Work Order ID 77751

Item Name: Crosstube Turning Detail

DRAWING NO. D212-664-141	TITLE XTUBE ASSY (205/212/412 HI FWD)	REV. D	DART AEROSPACE LTD ENGINEERING ORDER		D.E.O. NO. D212-664-141-D-1	SHEET NO. SHEET 1 OF 2	SCALE NTS
DRAWN	CHECKED	UP	MFG. APPR.	APPROVED	DE APPR.		
DATE 11.04.07	DATE 11.07.11		DATE 11.04.12	DATE 11/04/12	DATE 11.04.12

ADD AN INSPECTION WINDOW TO UNDERSIDE OF CROSSTUBE.

D212-664-141/-141B
ASSEMBLY DETAIL

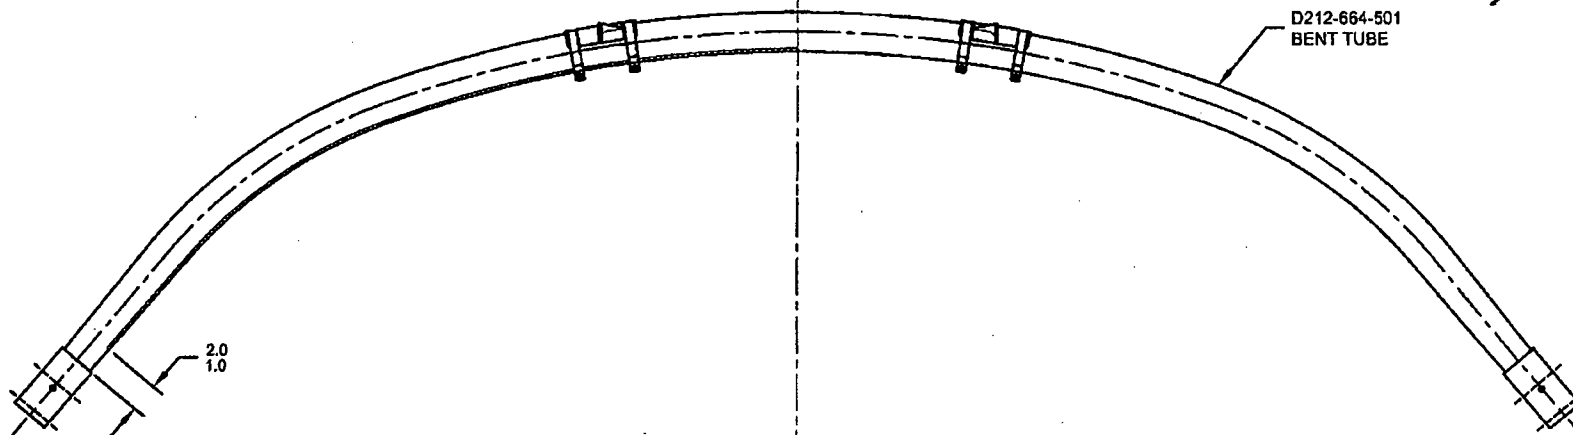
NOTES 2 OF SHEET 1 IS AMENDED AS FOLLOWS:

MASK AREA PRIOR TO PAINTING,
REMOVE MASKING AFTER PAINT
AND APPLY CLEAR COAT

- 2) FINISH: CHEMICAL CONVERSION COAT PER DART QSI 005 4.1
PRIME INSIDE AND OUTSIDE PER DART QSI 005 4.2
MASK UNDERSIDE OF CROSSTUBE AS SHOWN (HATCHED AREA) AND
PAINT OUTSIDE PER DART QSI 005 4.2
REMOVE MASKING AND APPLY CLEAR COAT
